SUBJECT: VOGTLE ELECTRIC GENERATING PLANT, UNITS 1 AND 2 - STAFF ASSESSMENT OF INFORMATION PROVIDED PURSUANT TO TITLE 10 OF THE *CODE OF FEDERAL REGULATIONS* PART 50, SECTION 50.54(f), SEISMIC HAZARD REEVALUATIONS RELATING TO RECOMMENDATION 2.1 OF THE NEAR-TERM TASK FORCE REVIEW OF INSIGHTS FROM THE FUKUSHIMA DAI-ICHI ACCIDENT (TAC NOS. MF3770 AND MF3771)

STAFF ASSESSMENT BY THE OFFICE OF NUCLEAR REACTOR REGULATION

RELATED TO SEISMIC HAZARD AND SCREENING REPORT

VOGTLE ELECTRIC GENERATING PLANT, UNIT NOS. 1 AND 2

Figure 3.3-1 Plot of Staff's and Licensee's Base Case Shear-Wave Velocity Profiles for Vogtle Units 1 and 2

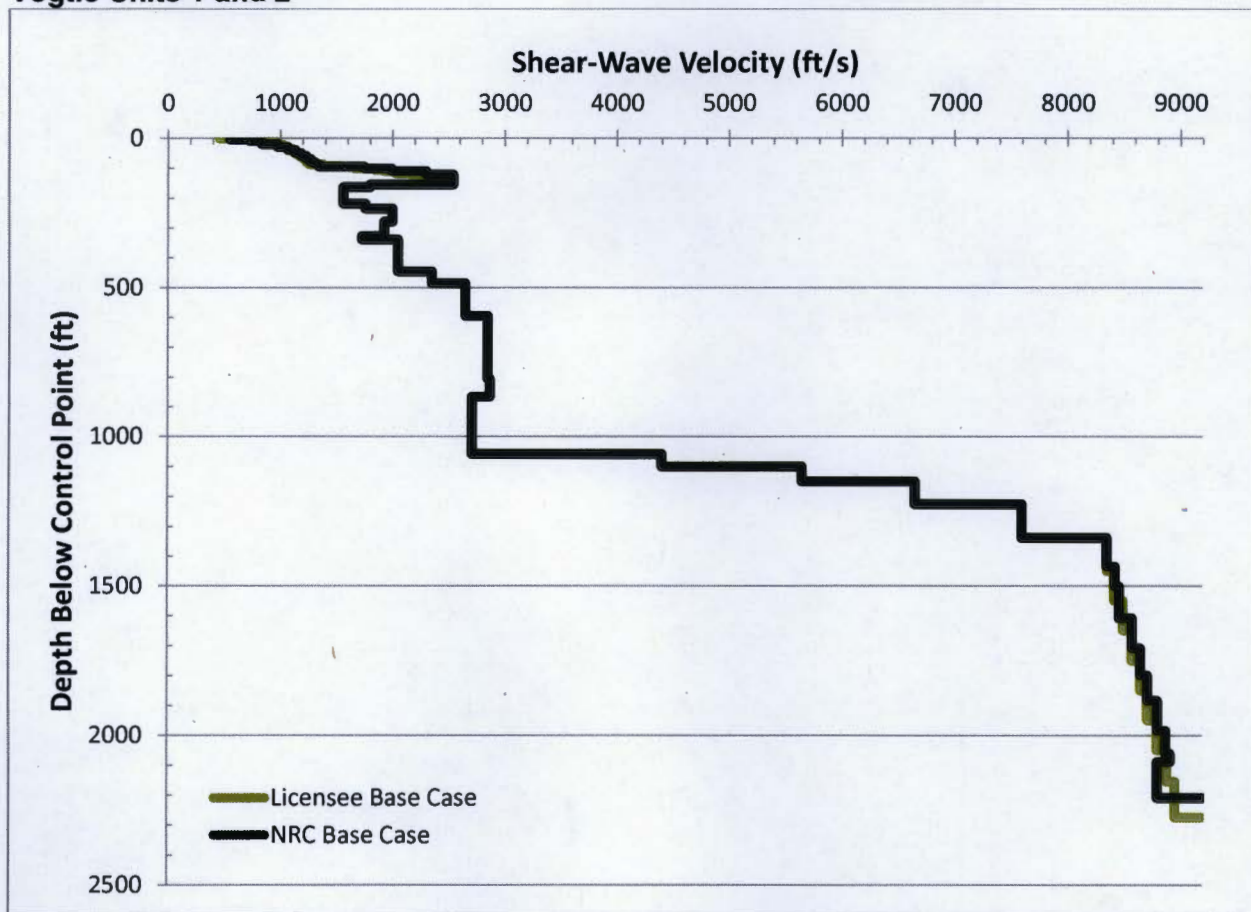
To confirm the licensee's site response analysis, the staff performed site response calculations for the Vogtle site. The staff independently developed a shear-wave velocity profile, damping values, and modeled the potential nonlinear behavior of the rock using measurements and geologic information provided in the Vogtle, Units 1 and 2 UFSAR (SNC, 2014) and the Vogtle, Units 3 and 4 Site Safety Analysis Report (SSAR) (SNC, 2008). Because the site is very well characterized and the velocities reported at the Vogtle, Units 1 and 2 and the Vogtle, Units 3 and 4 sites are similar, the staff used the base case profiles from the Vogtle, Units 3 and 4 SSAR (SNC, 2008). The staff based its profile on the single base case profile for the soils above the Triassic basin and the weighted mean of the six alternative base case profiles for the sedimentary rocks of the Triassic basin. To capture uncertainty in the depth to hard rock, the staff randomized the best estimate depth to base rock of 2,209 ft [673 m] by ± 20 percent. Figure 3.3-1 shows the staff base case shear-wave velocity profiles compared to the base case profiles developed by the licensee. The licensee's and staff's base case shear-wave velocity profiles in the upper 1,058 ft are very similar. The observed differences in the approximate depth range of 100 to 153 ft, which corresponds to the Blue Bluff Marl, are because the licensee considered shear-wave velocity data from the ISFSI, Units 1 and 2, and Units 3 and 4 areas, while the staff used the shear-wave velocity profiles presented in the Vogtle, Units 3 and 4 SSAR. Differences in the depth to hard rock are due to different averaging methods used to calculate thicknesses and velocities of the rocks in the Triassic basin.

Figure 3.3-1 Plot Comparing the Staff's and the License's Median Amplification Functions and Uncertainties for two input loading levels for Vogtle Units 1 and 2

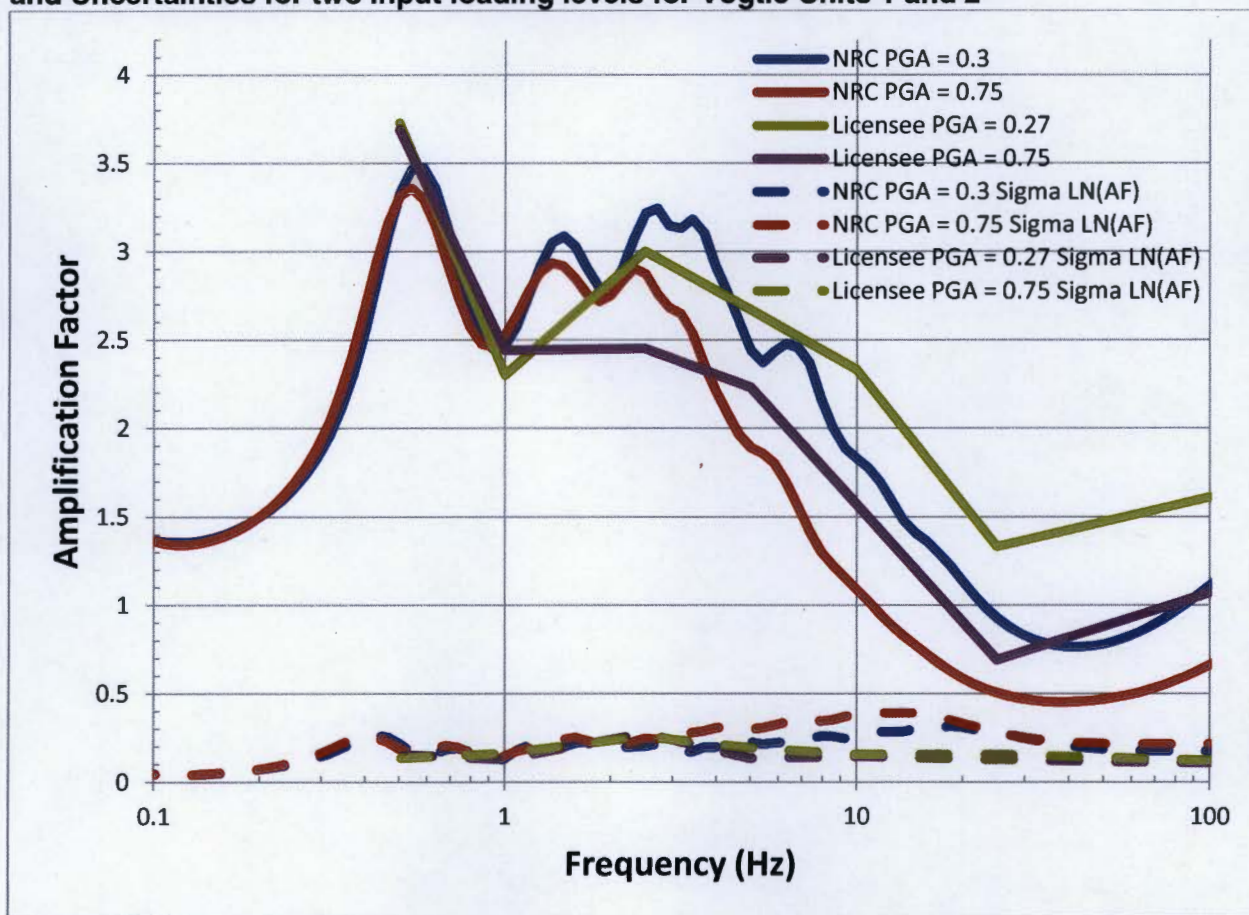
Figure 3.3-2 shows a comparison of the staff's and licensee's median site amplification functions and uncertainties (± 1 standard deviation) for two of the input loading levels. The licensee's approach to modeling the subsurface rock properties and their uncertainty results in amplification factors similar to those developed by the staff. As shown in Figure 3.3-3, these small differences in the site response analysis do not have a large impact on the control point seismic hazard

curves or the resulting GMRS, as discussed below. Appendix B of the SPID provides guidance for performing site response analyses, including capturing the uncertainty for sites with less subsurface data; however, the guidance is neither entirely prescriptive nor comprehensive. As such, alternative approaches in performing site response analyses, including the modeling of uncertainty, are acceptable for this application.

Figure 3.3-2 Plot Comparing the Staff's and the Licensee's Mean Control Point Hazard Curves at a Variety of Frequencies for Vogtle Units 1 and 2

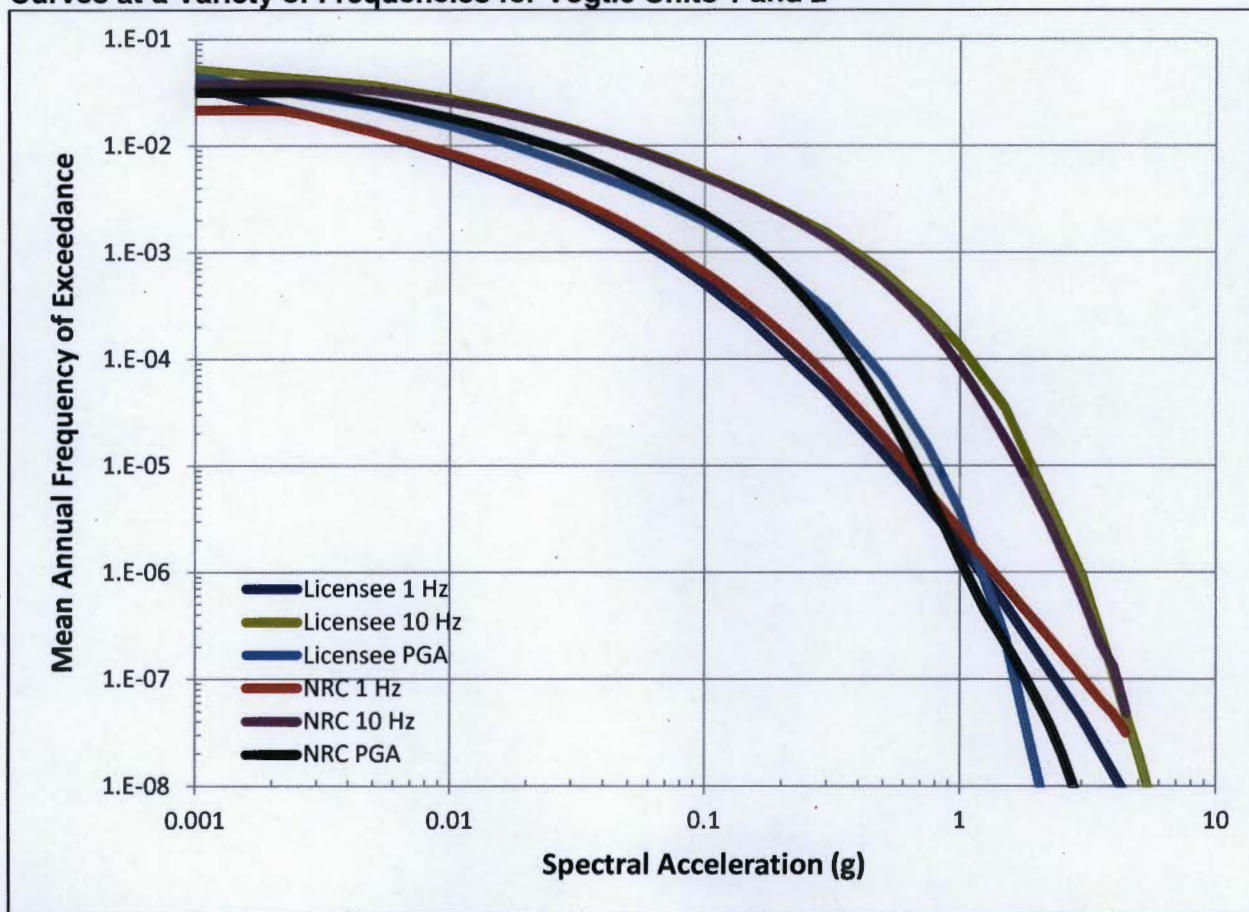
In summary, the staff concludes that the licensee's site response was conducted using present-day guidance and methodology, including the NRC-endorsed SPID. The staff performed independent calculations which confirmed that the licensee's amplification factors and control point hazard curves adequately characterize the site response, including the uncertainty associated with the subsurface material properties, for the Vogtle site.

Figure 3.4-1 Comparison of the Staff's GMRS with Licensee's GMRS and the SSE for Vogtle Units 1 and 2

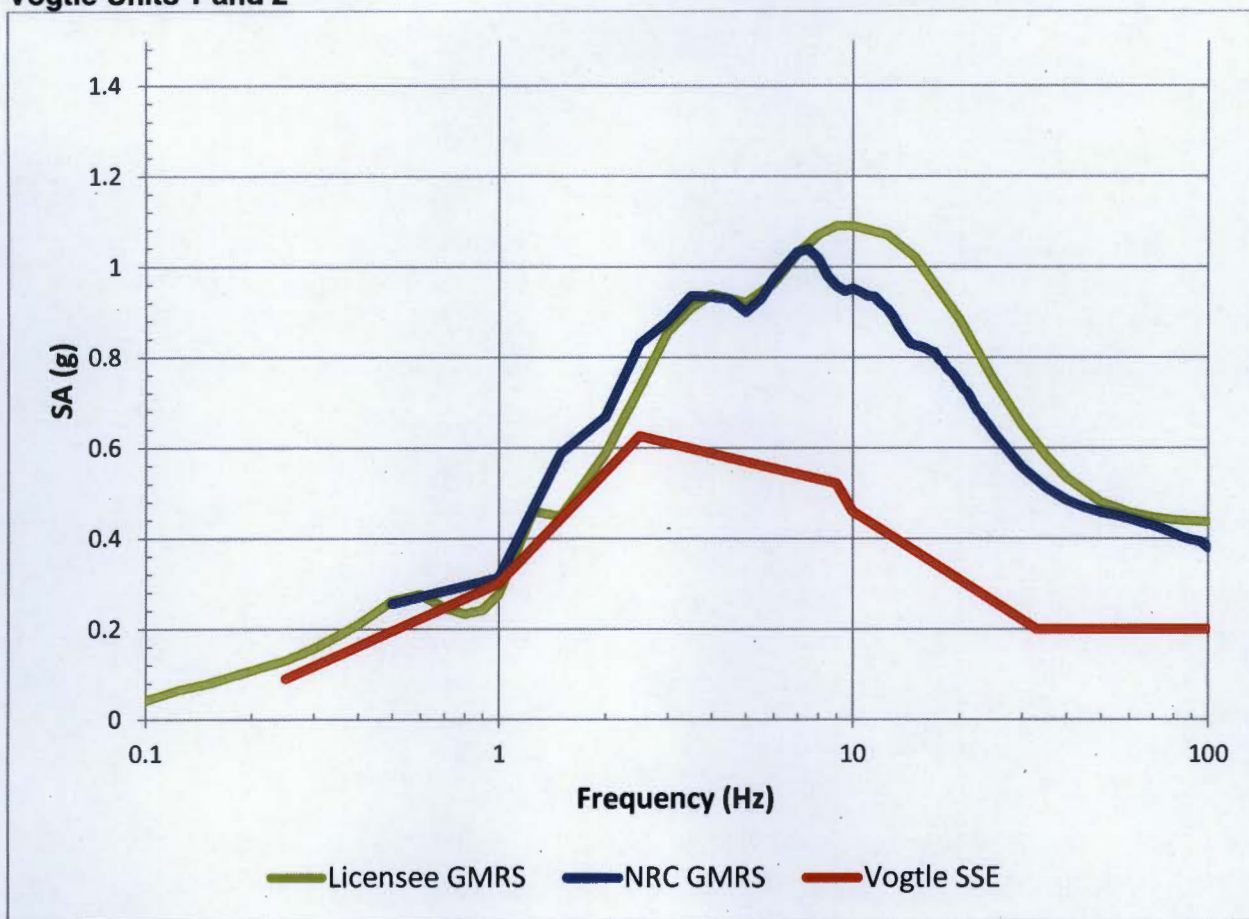
The staff independently calculated the 10^{-4} and 10^{-5} UHRS using the results of its confirmatory PSHA and site response analyses, as described in Sections 3.2 and 3.3 of this staff assessment, respectively. As shown in Figure 3.4-1 below, the licensee's GMRS shape is generally similar to that calculated by the staff.

The staff confirms that the licensee used the present-day guidance and methodology outlined in RG 1.208 and the SPID to calculate the horizontal GMRS, as requested in the 50.54(f) letter. The staff performed both a PSHA and site response confirmatory analysis and achieved results consistent with the licensee's horizontal GMRS. As such, the staff concludes that the GMRS determined by the licensee adequately characterizes the reevaluated hazard for the Vogtle site. Therefore, this GMRS is suitable for use in subsequent evaluations and confirmations, as needed, for the response to the 50.54(f) letter.
